STATE OF MARYLAND CRITICAL AREA COMMISSION CHESAPEAKE AND ATLANTIC COASTAL BAYS

May 18, 2009

RE: SM 20-08 St. Mary's Ryken High School Expansion

Thank you for providing the revised plans and pollutant removal calculations for the referenced project. I have reviewed the information, and I have the following comments:

SWM DRAINAGE AREA MAP

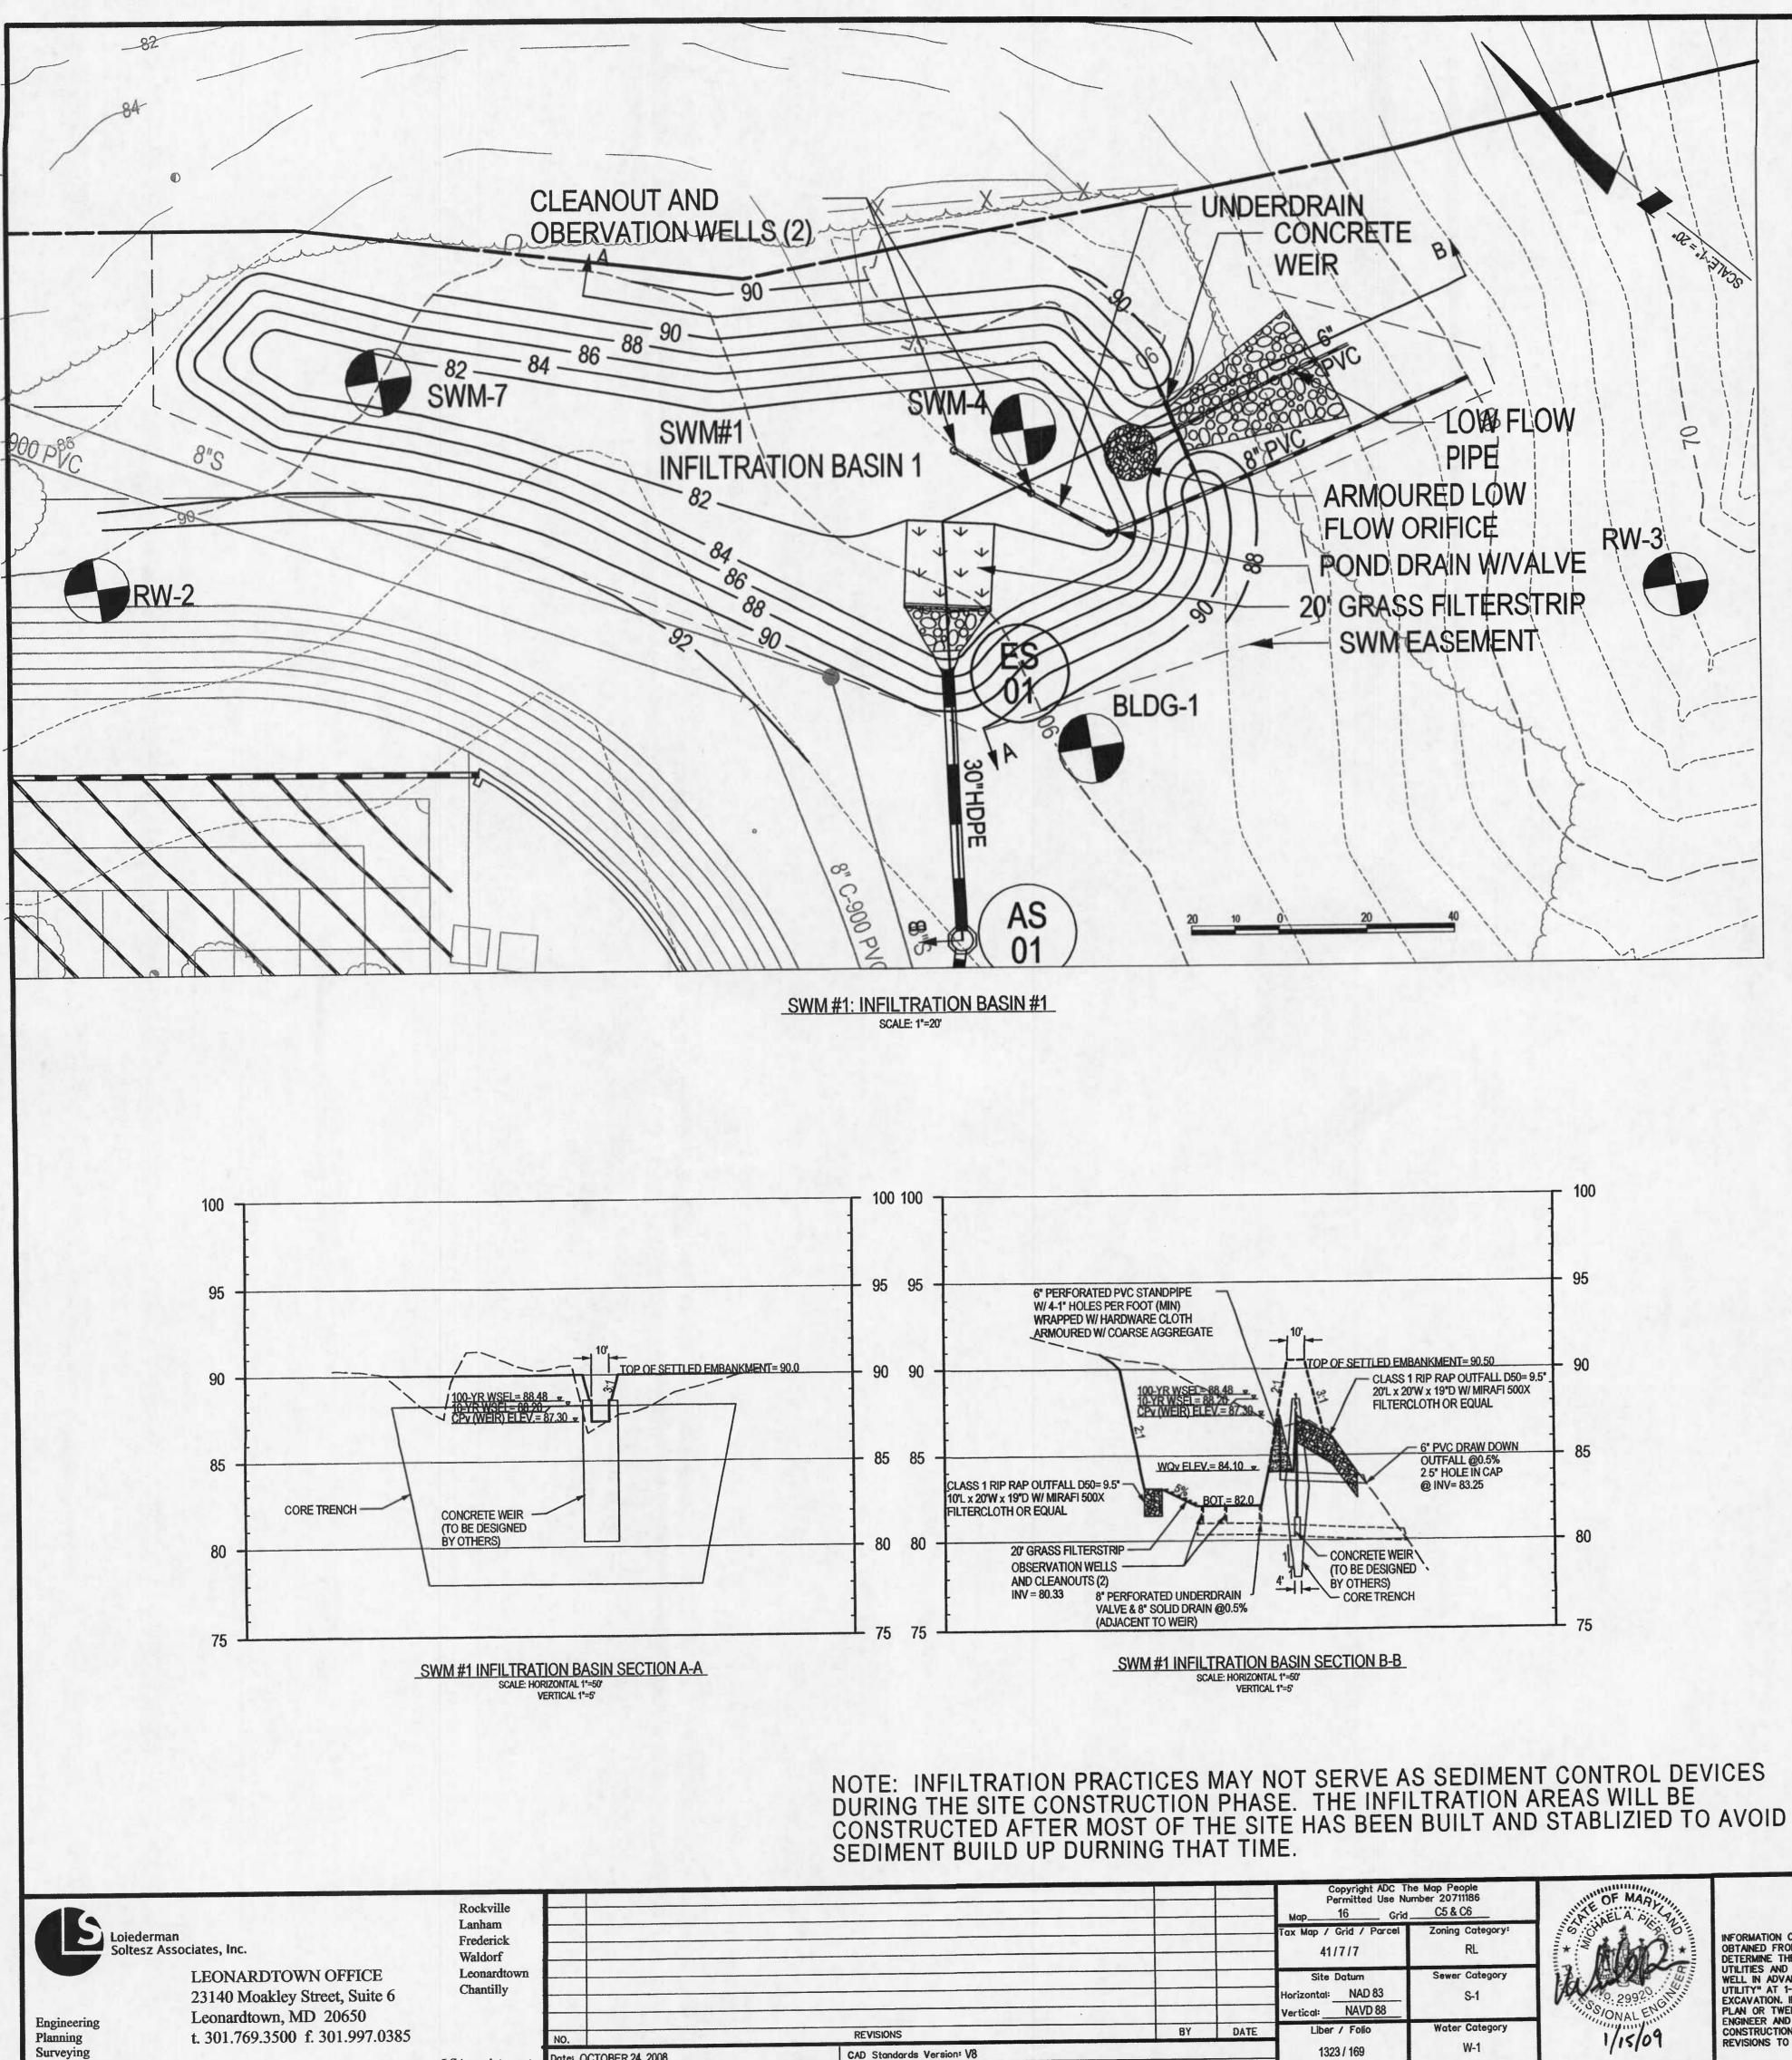
- 1. The pollutant removal calculations have been correctly revised to address the entire area of the site (10.79 acres) that is designated as an Intensely Developed Area (IDA). The area of the sidewalks has been included in the area of the parking lot for a total impervious area of 3.35 acres. Two structural stormwater treatment practices are proposed, an infiltration trench and a bioretention area, and they will address 2.46 pounds of the total 2.8 pounds of pollutant removal required. The remaining 0.34 pounds will be addressed by planting 48 trees and 61 shrubs adjacent to the entrance road and between the stormwater outfalls. (At a removal rate equivalency of 2.0 pounds of phosphorus per acre of planting per year, the proposed plantings equate to 0.17 acres and will provide the 0.34 pounds of removal required and also stabilize the slope between the outfalls.)

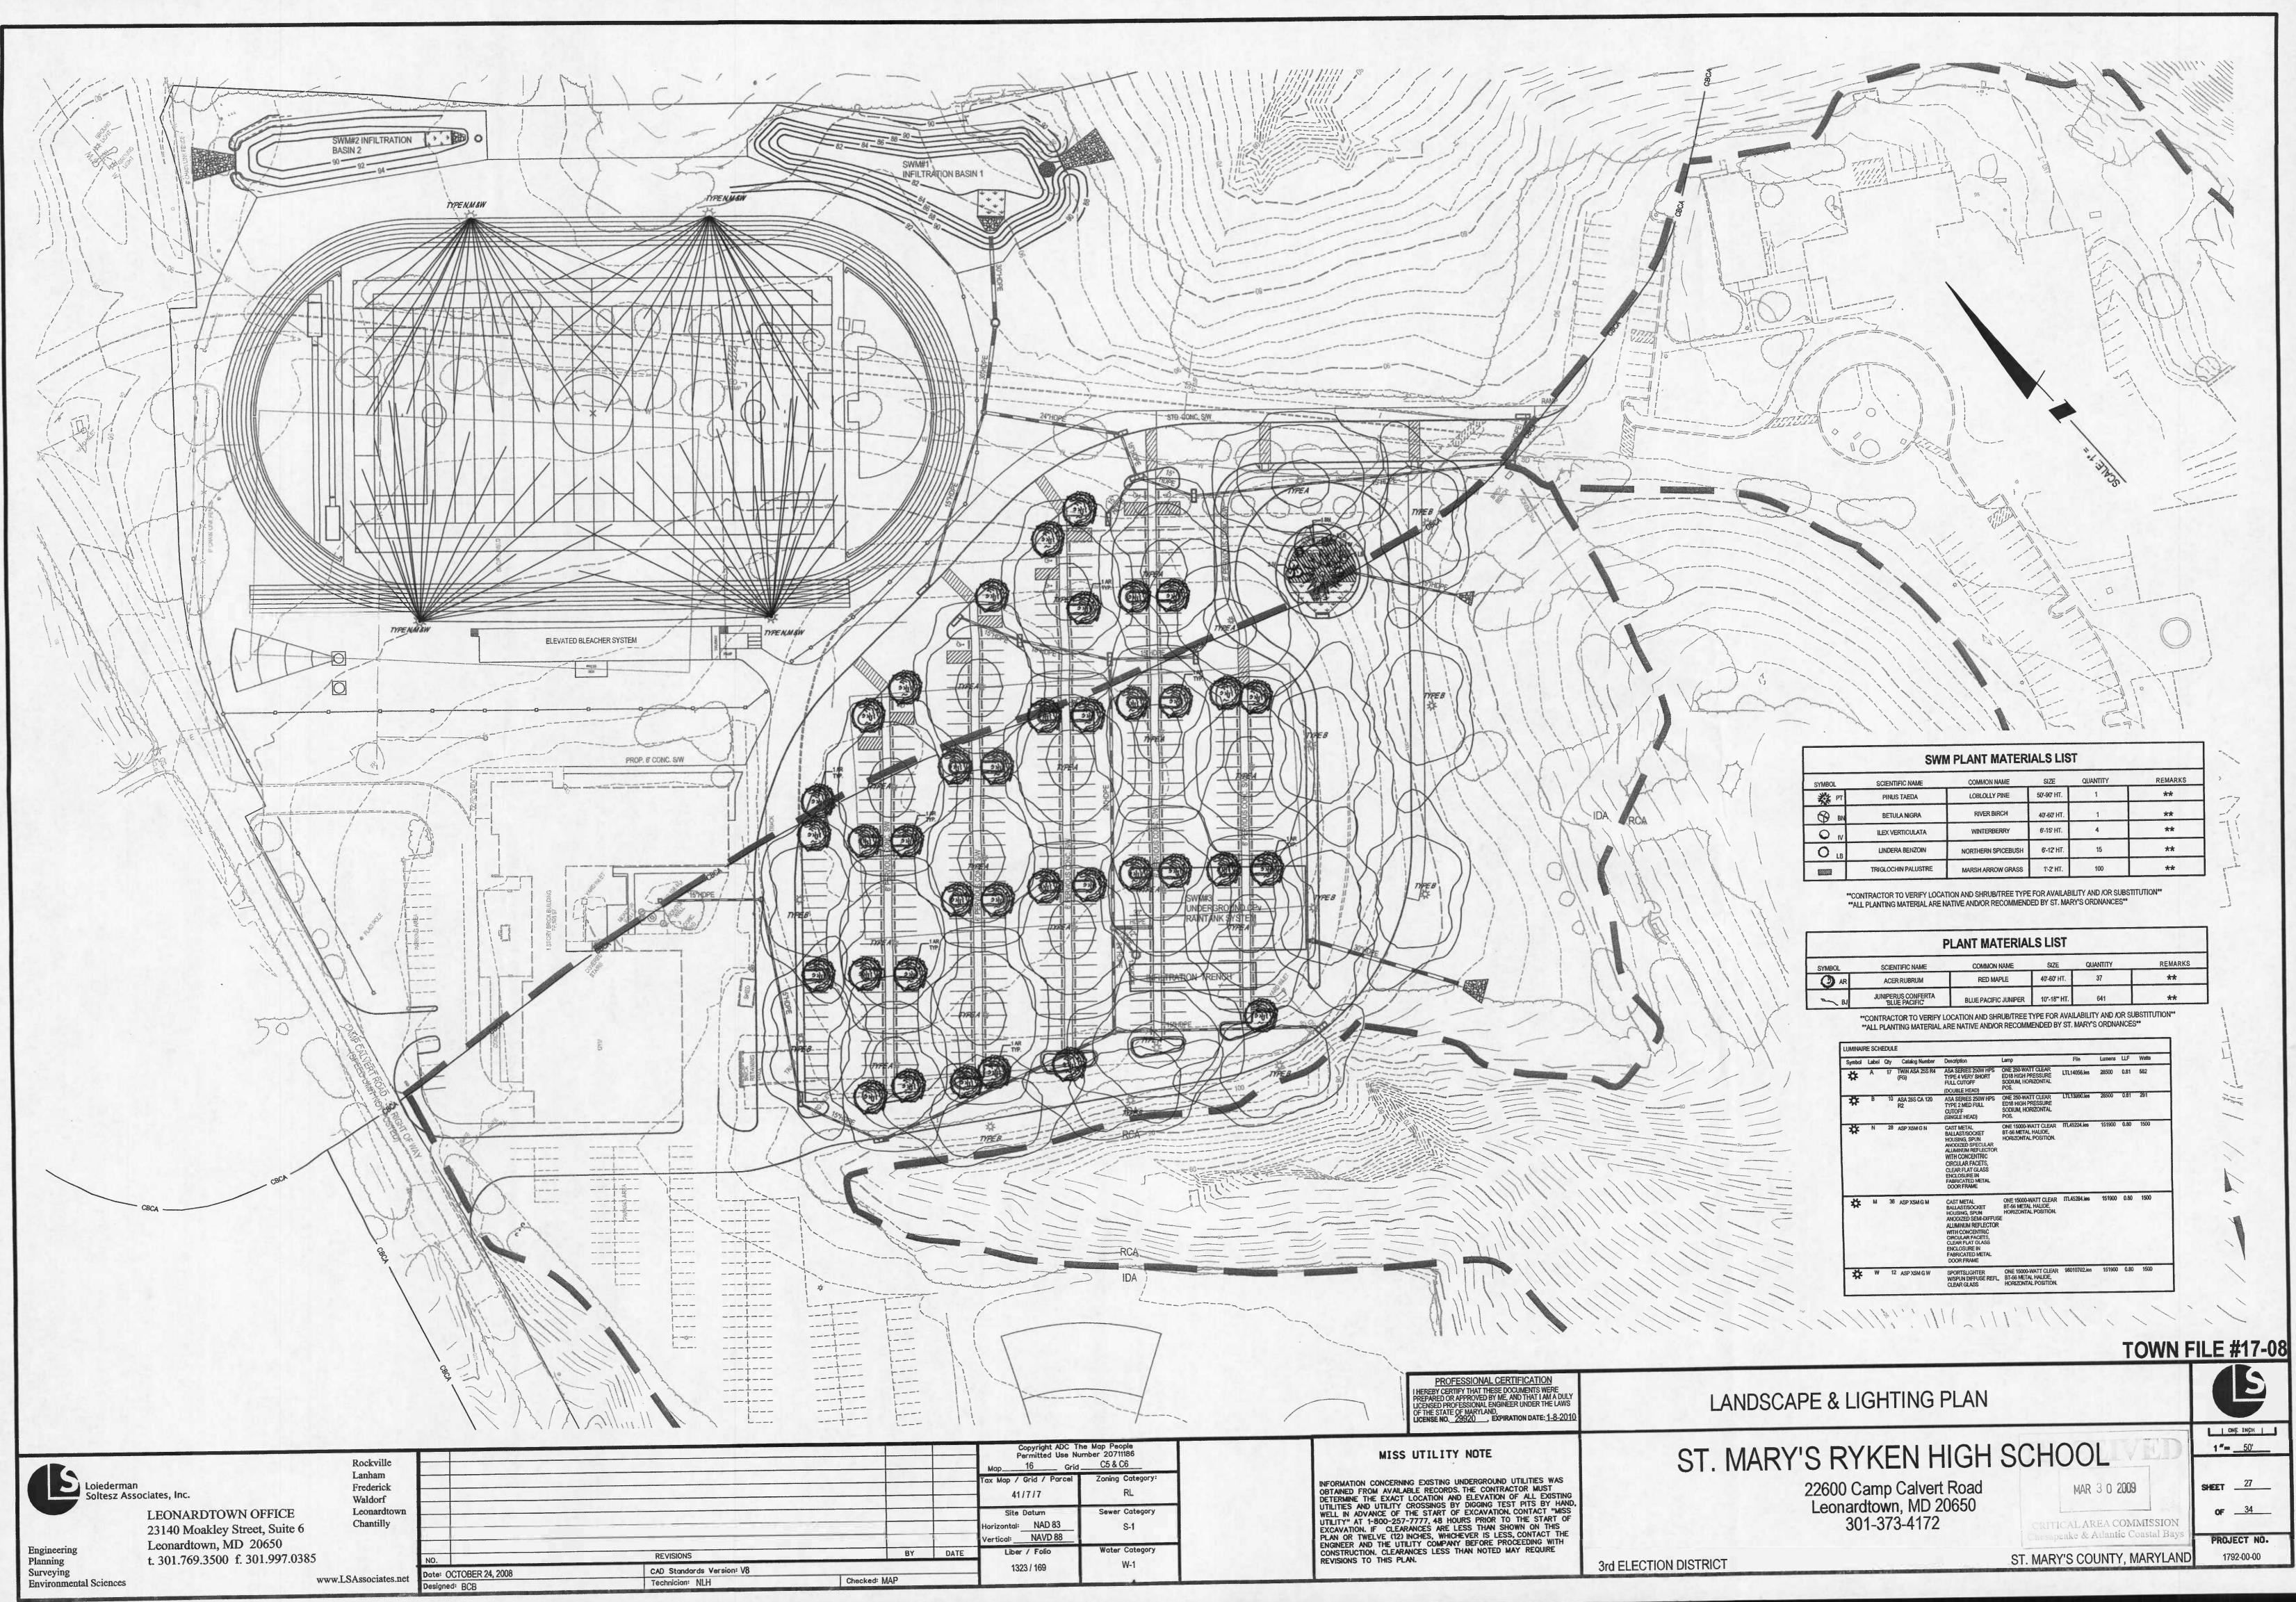
4. The proposed parking lot plantings are native species and should adapt well to that environment. The proposed bioretention area plantings are native species and are acceptable for that location. The proposed supplemental pollutant removal plantings (identified on the "Bufferyard Planting List") are native species and appear to be suitable to the site conditions. All plantings should be covered by a maintenance agreement and a replacement guarantee for two years. The plantings in the bioretention area and provided as supplemental removal plantings are "required plantings" and must be permanently maintained. This means that if the plants die, they must be replaced in kind or with another native plant species, unless sufficient natural regeneration has taken place to maintain the water quality function provided by the original design. It is recommended that the maintenance officials at St. Mary's-Ryken High School retain a copy of the "Landscape Plan" for their records.
